March 16, 2021

I am writing to briefly share our suggestions regarding the MISO Renewable Impacts Integration Assessment (RIIA), dated February 2021. As you know, America's Power advocates on behalf of coal-fired generation.

Technical Comments on MISO's Renewable Integration Impact Assessment March 9, 2021

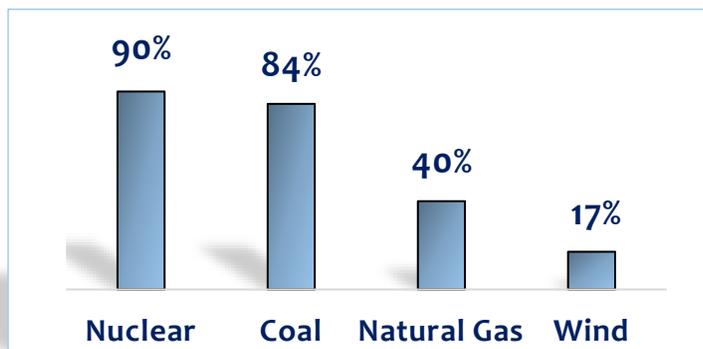
Below is a chart that shows the capacity factors of MISO’s predominant electricity resources during February 15-18.

Nuclear and coal responded very well. In other words, they were resilient to extreme weather conditions. The ability of gas to respond was limited by supply disruptions and increased demand for heating. The output of wind dropped to almost half that of the previous month.
